Wisconsin Department of Transportation

Proposal #21: 4996-01-58, WISC 2015 144
Taylor Drive, City of Sheboygan
Kohler Memorial Drive – Crocker Avenue
Local Street
Sheboygan County

This is Addendum No. 01, which provides for the following:

ADDENDUM NO. 01

SECTION, NOTES & QUANTITIES
 SHEET 10 OF 25
 273

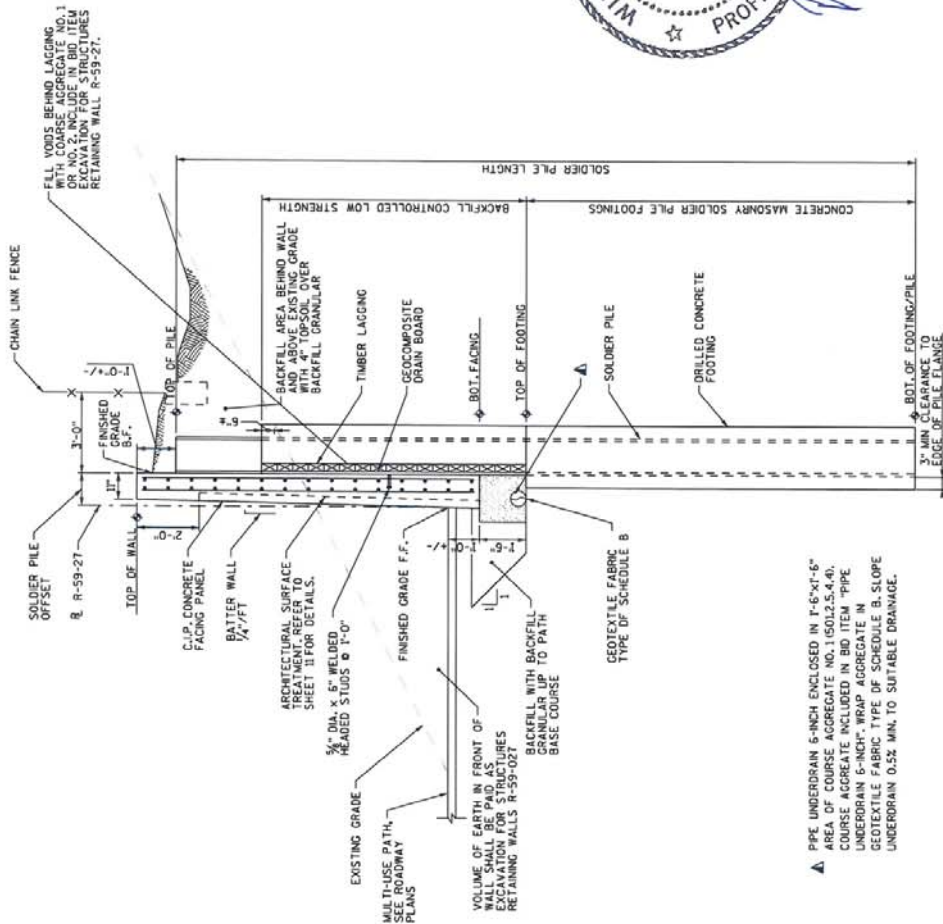
Revised Plan Sheets	
Plan Sheet	Plan Sheet Title (brief description of changes to sheet)
273	Structure R-59-27 Section, Note & Quantities(updated quantity for item 505.0615)
278	Structure R-59-27 Panel Details 13 thru 16 (changed number of spaces for panels 14, 15, and 16. 24 spaces should be 27 spaces. Overall dimension was correct as shown.)
279	Structure R-59-27 Panel Details 17 thru 20 (changed number of spaces for panel 17. 24 spaces should be 27 spaces. Overall dimension was correct as shown.)
288	Structure R-59-27 Bill of Bars (revise the number of required bars for vertical bars, horizontal bars, and bar series tables)
290	Structure R-59-32 Section, Notes & Quantities (sleeve for fence post foundation)

Addendum No. 01
 ID 4996-01-58
 Revised Sheet 273
 October 26, 2015

1 10/22/15 SLEEVE FOR FENCE FOUNDATION TLK
NO. DATE REVISION BY
STATE OF WISCONSIN
DEPARTMENT OF TRANSPORTATION
STRUCTURE R-59-32
BRN. KAG. P.E.
SECTION, NOTES & QUANTITIES
SHEET 2 OF 3
290

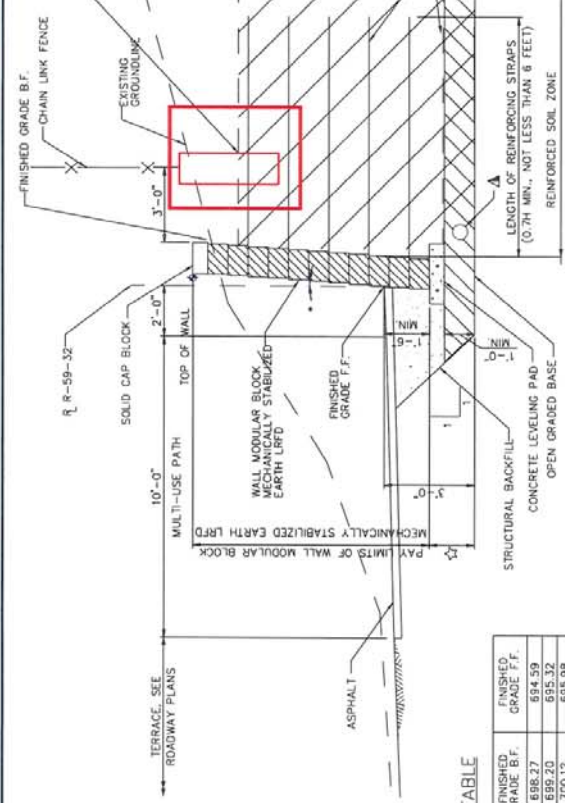
PROVIDE SLEEVE FOR FENCE FOUNDATION. COORDINATE MATERIAL AND SIZE OF SLEEVE WITH FENCE. SLEEVE INCIDENTAL TO WALL. MODULAR BLOCK MECHANICALLY STABILIZED EARTH LRFD R-59-32

Addendum No. 01
ID 4996-01-58
Revised Sheet 290
October 26, 2015
